**PRE-FINAL REMEDIAL DESIGN REPORT
AND
DRAFT REMEDIAL ACTION WORK PLAN**

GYPSUM STACK ROADS

**SIMPLOT PLANT AREA
EASTERN MICHAUD FLATS SUPERFUND SITE**

August 1, 2002

**GYPSUM STACK
ROADS SITE PLAN**

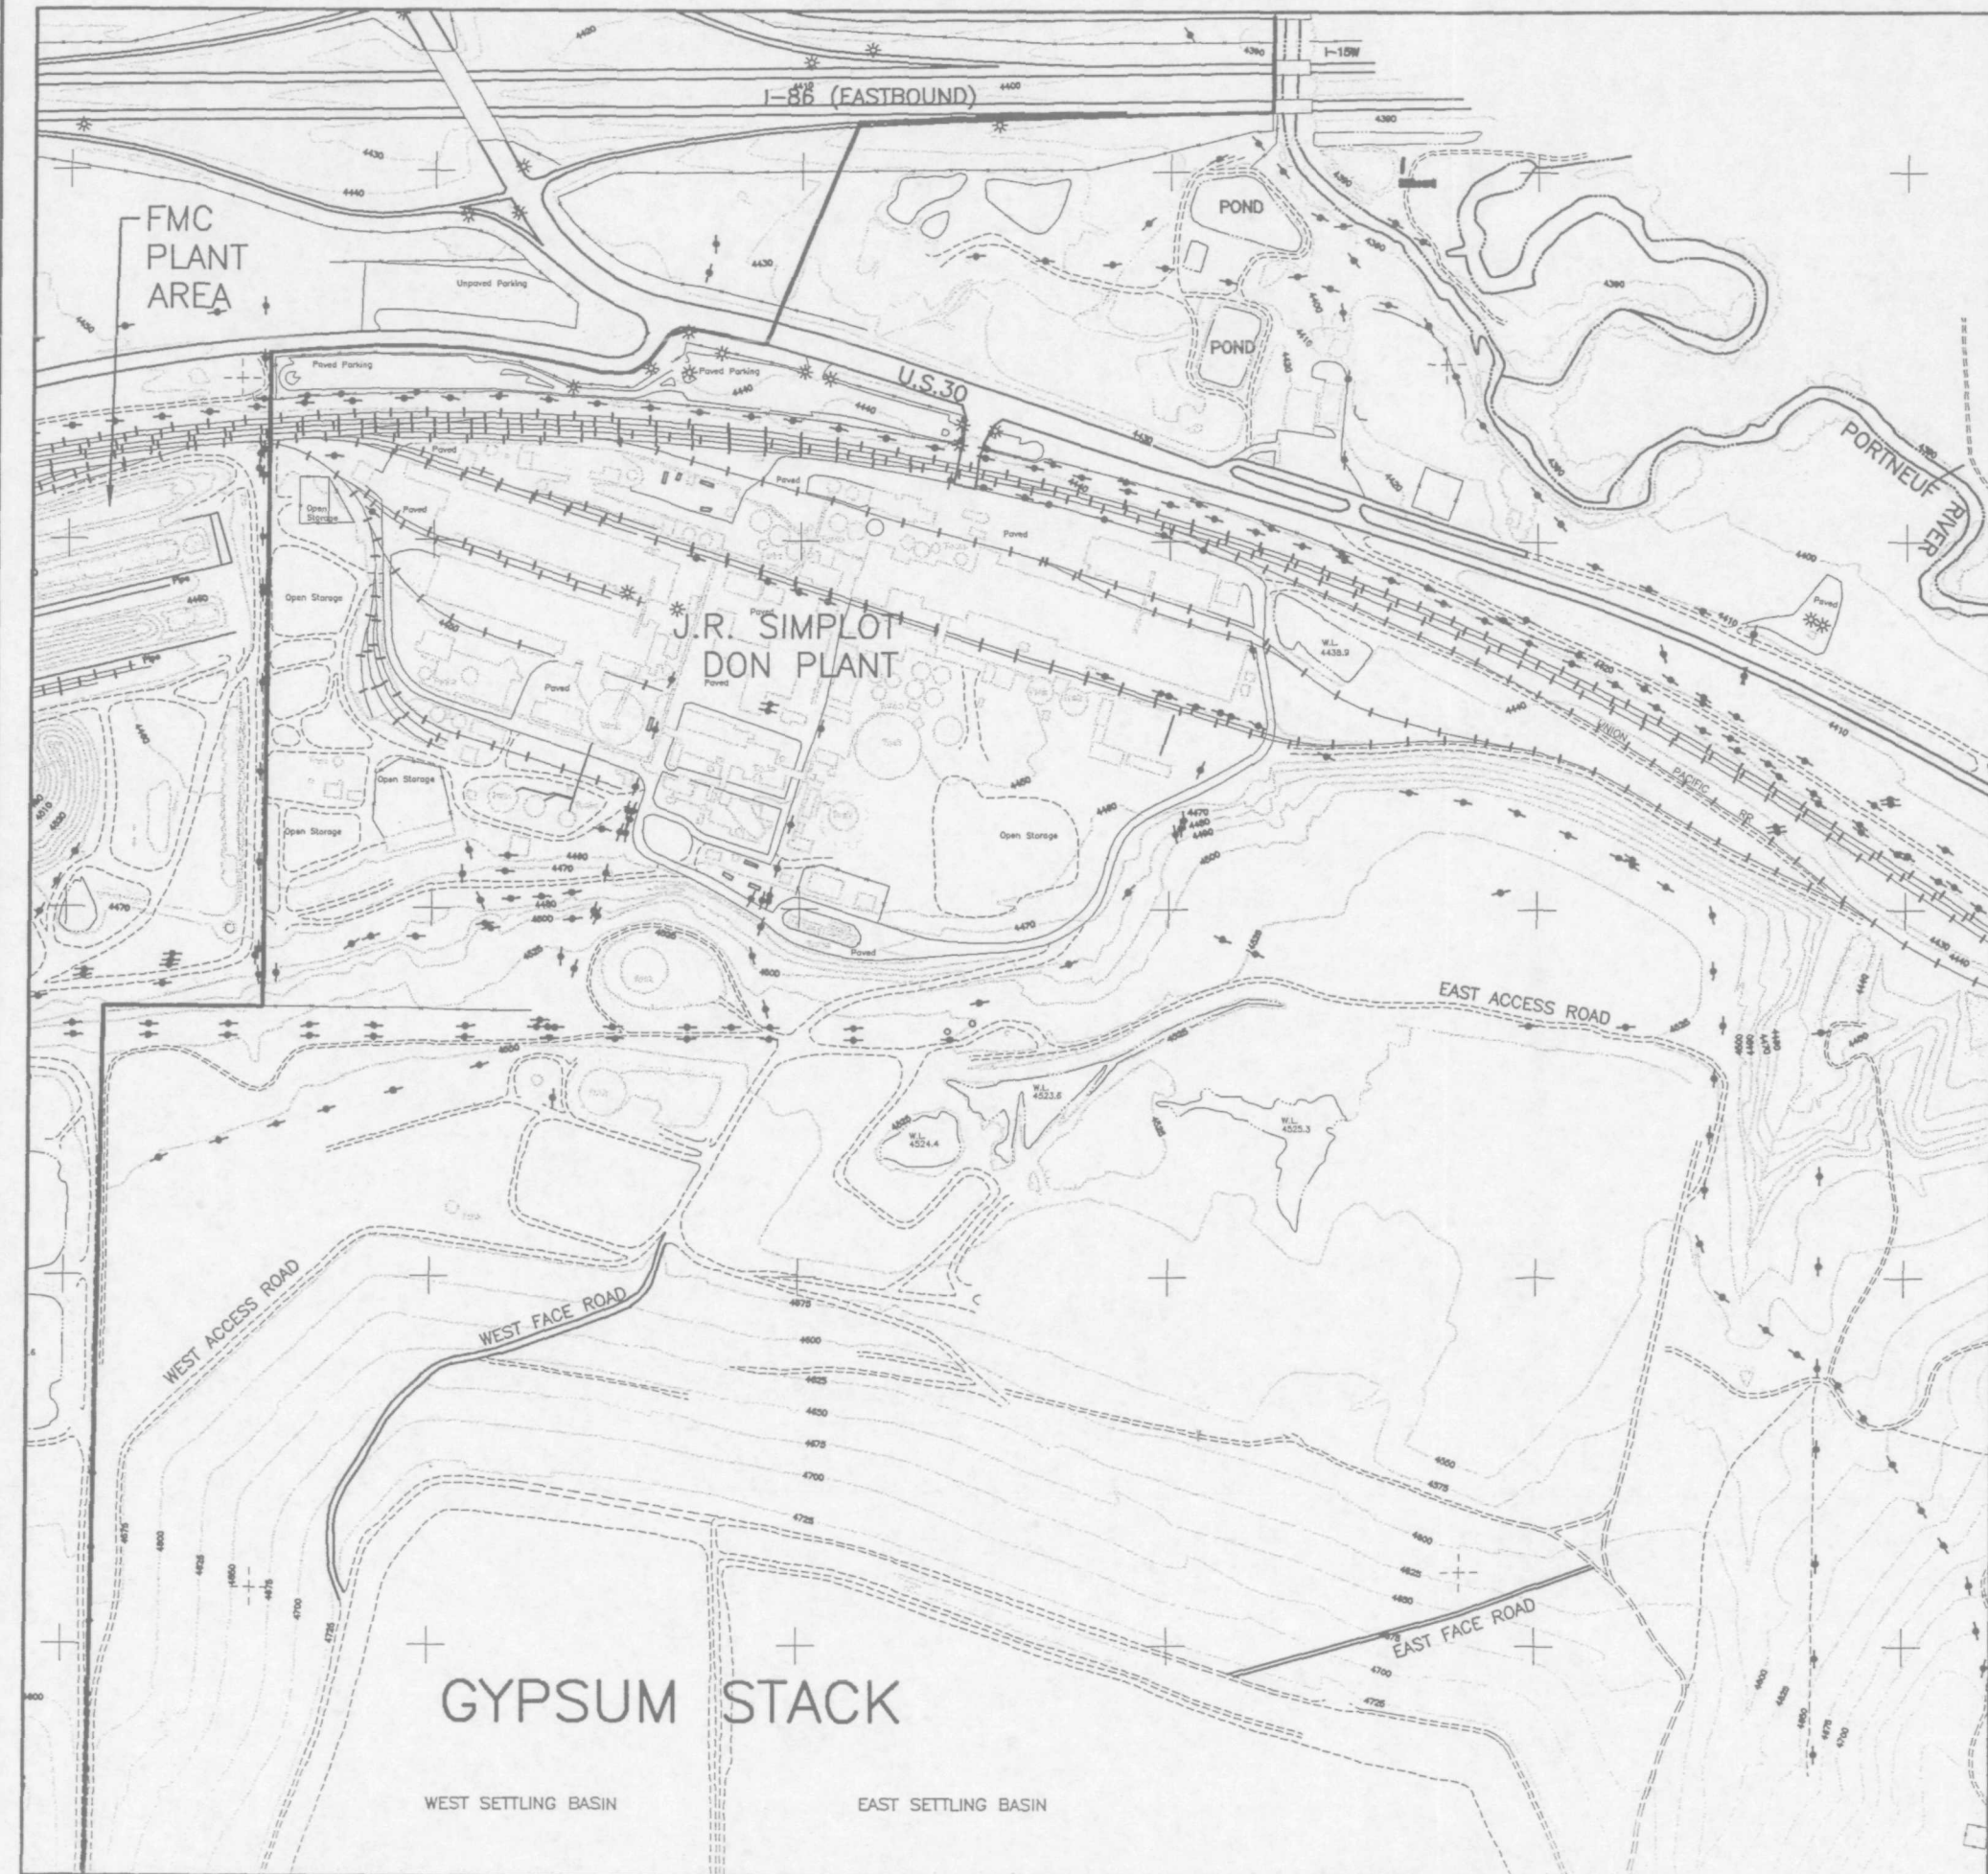
*need to include all
permanent
roads on
stack*

*
what is diff if they are on the face or not?
